AGENDA PACKET

MAY 18, 2021 MEETING

AGENDA

Tuesday, May 18, 2021

OVERALL SITE PLAN

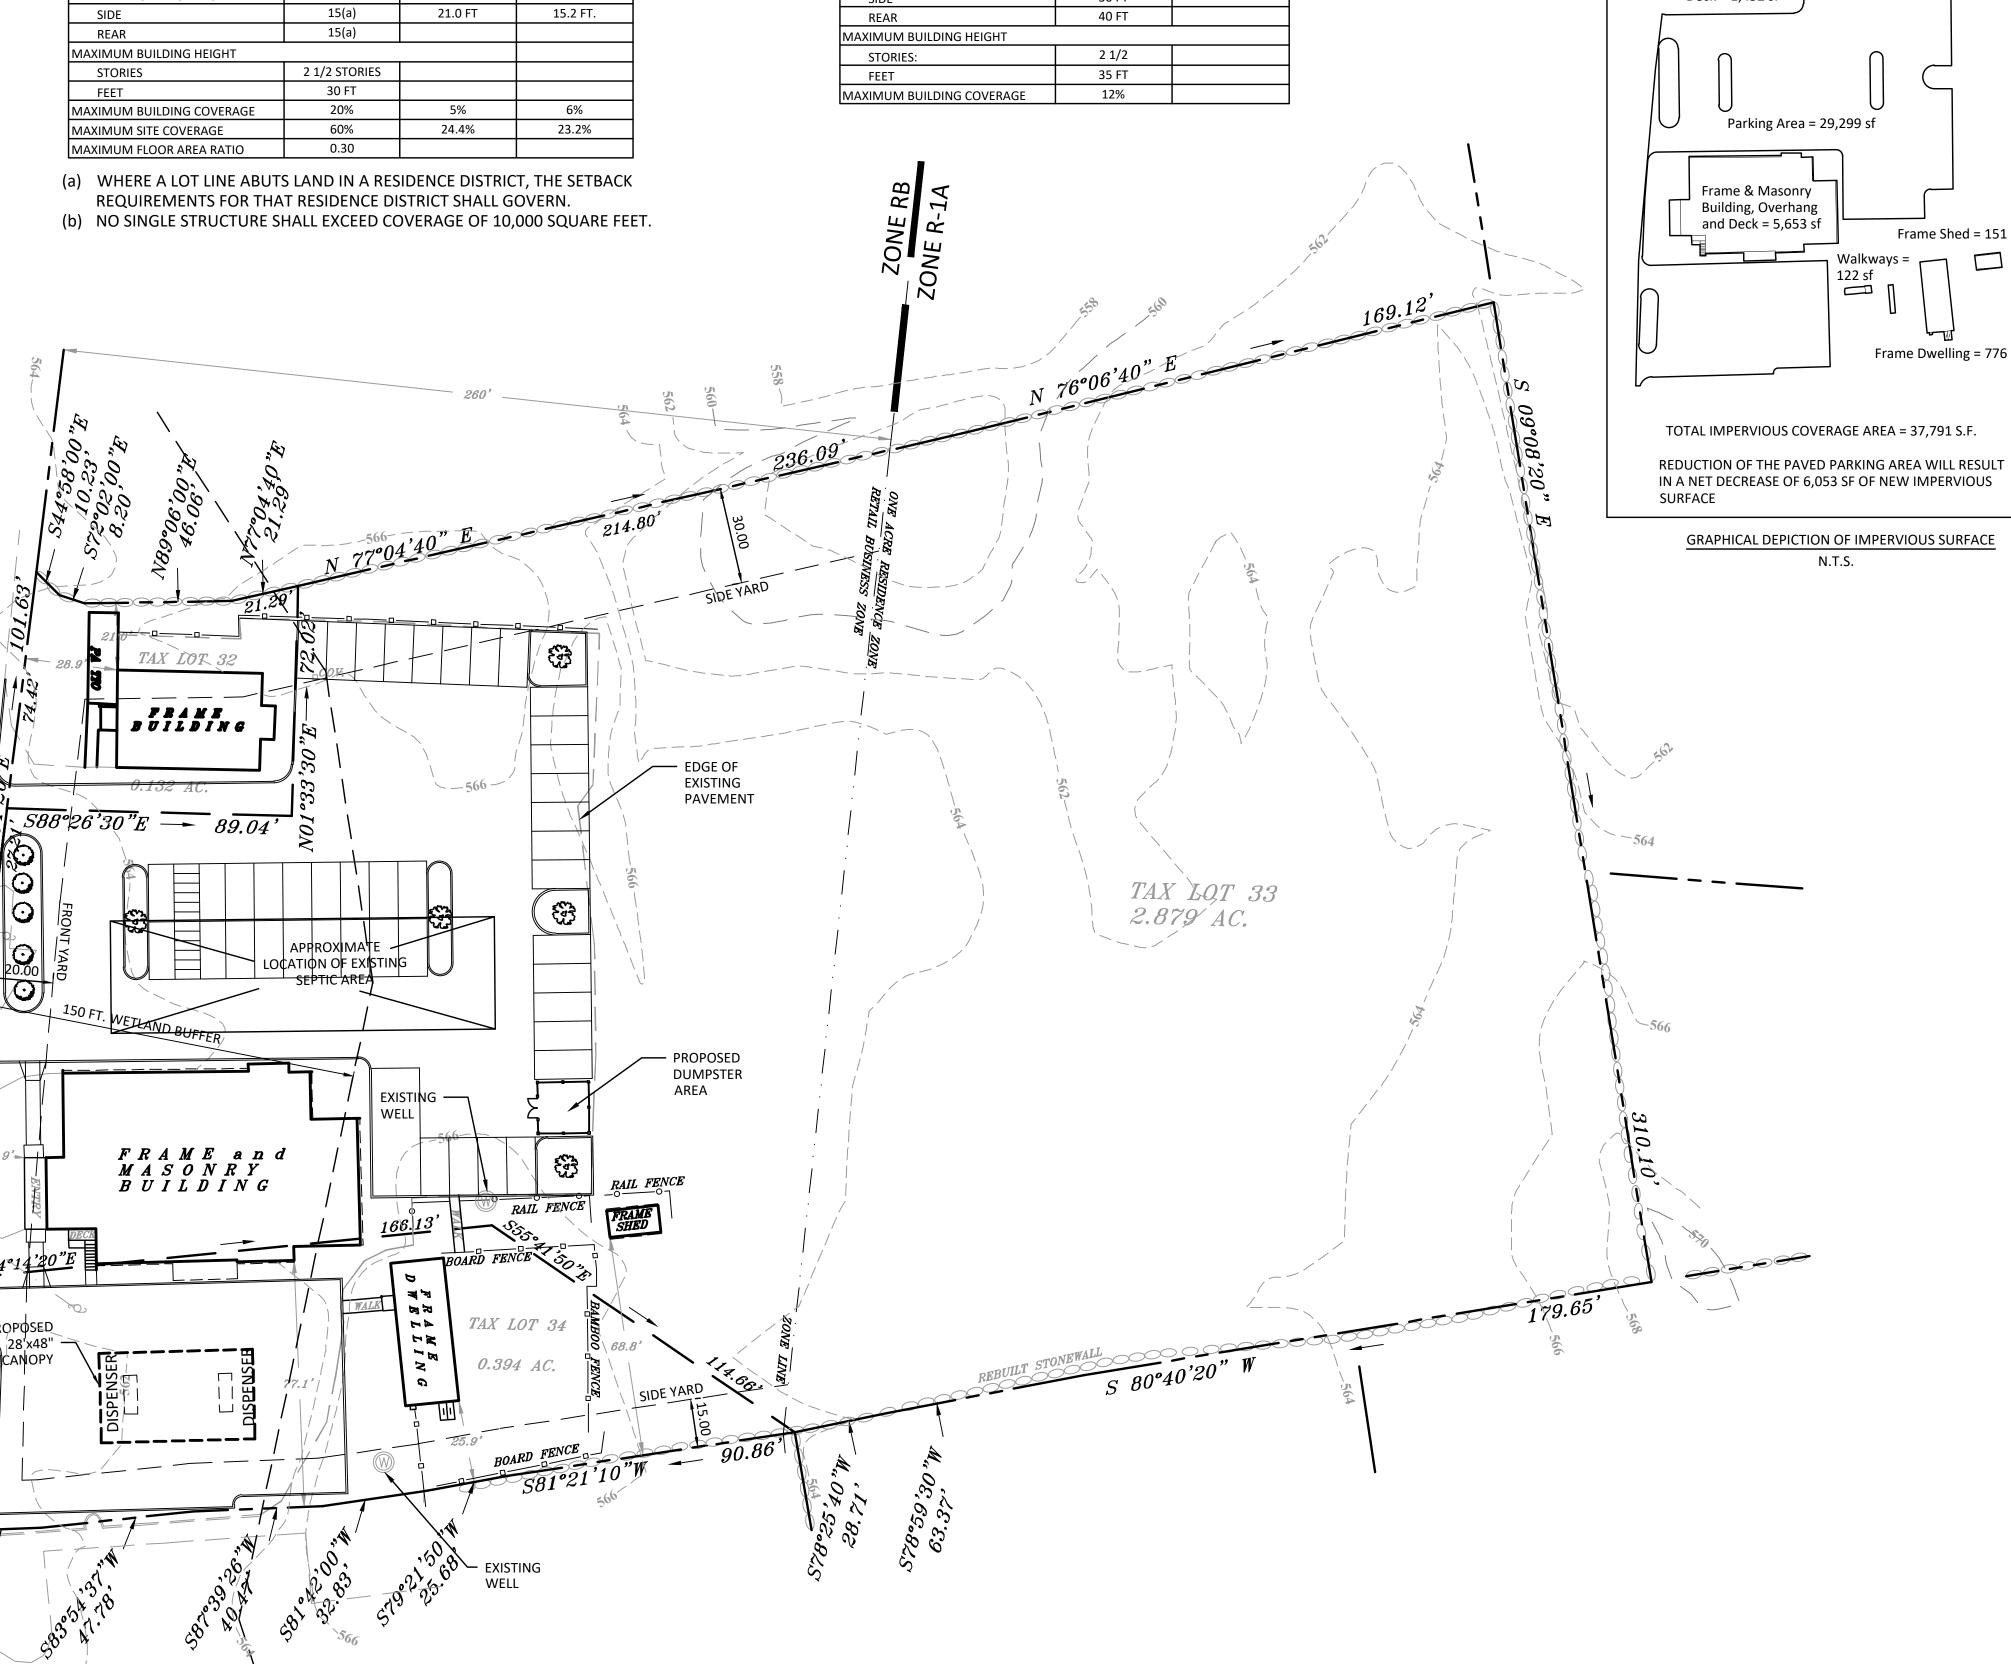
- 9. The Bulk Zoning Table shall be revised to compare the requirements of the underlying zoning district to the existing and proposed condition; several necessary items on this table have been left blank. Required variances and existing nonconformities shall be noted below the table.

- 10. The site plan shall include a parking calculation demonstrating compliance with the off-street parking requirements provided under Section 220-56 of the Zoning Code. In order to confirm the parking calculation as being accurate, the applicant shall provide a floor plan or key plan which graphically shades or depicts the various uses that are included in the parking calculation/requirement along with associated floor areas (s.f.).

- 14. The fuel tank locations shall be illustrated on the plan; will diesel fuel be provided?
- 15. Provide a fuel truck delivery turning and maneuvering plan.

- 16. The plan shall illustrate and quantify the limits of disturbance (s.f.). The plan shall note that disturbance limits shall be staked in the field prior to construction.

- 17. Include erosion control measures on the plan, including, but not limited to, temporary construction access, silt fence, inlet protection, tree protection, construction sequence, etc. Details shall be provided and shall be in conformance with the most recent version of the New York State Standards and Specifications for Erosion and Sediment Control.

- 18. The as-built of the septic system shall be provided to demonstrate that work proposed over the system will not create an impact.
- 19. The applicant shall develop a wetland mitigation plan which provides, at a minimum, mitigation at a ratio of 1:1 (for every s.f. of wetland or wetland buffer disturbance proposed, an equal or greater amount of mitigation shall be provided). It is recommended that wetland mitigation take the form of stormwater quality improvements.

COVER

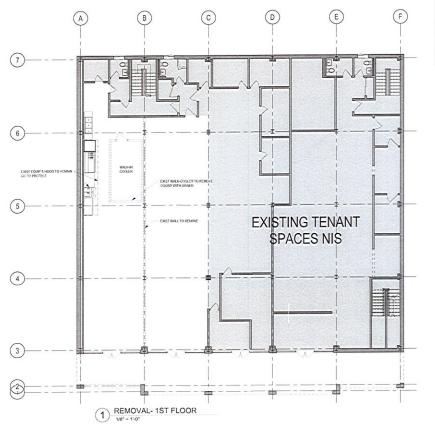
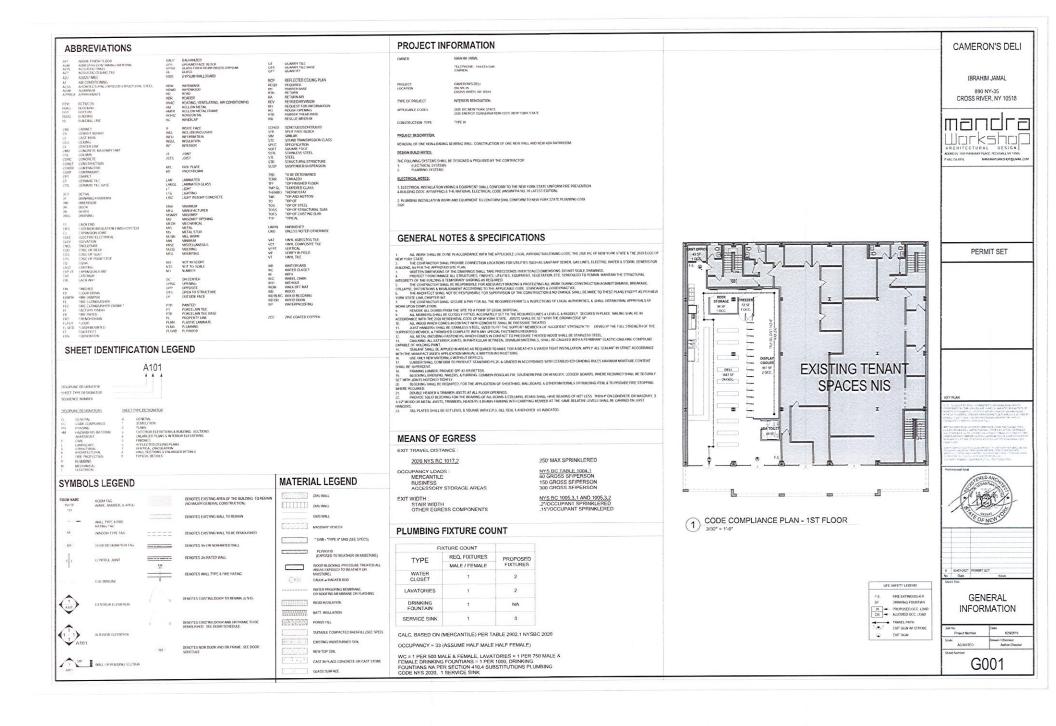
- 12. The plans shall be revised to include a north arrow; the Site Plan on Sheet T1 shall be revised to include a drawing scale.
 - 13. The Tax Parcel Identification Number(s) shall be identified on the plan.
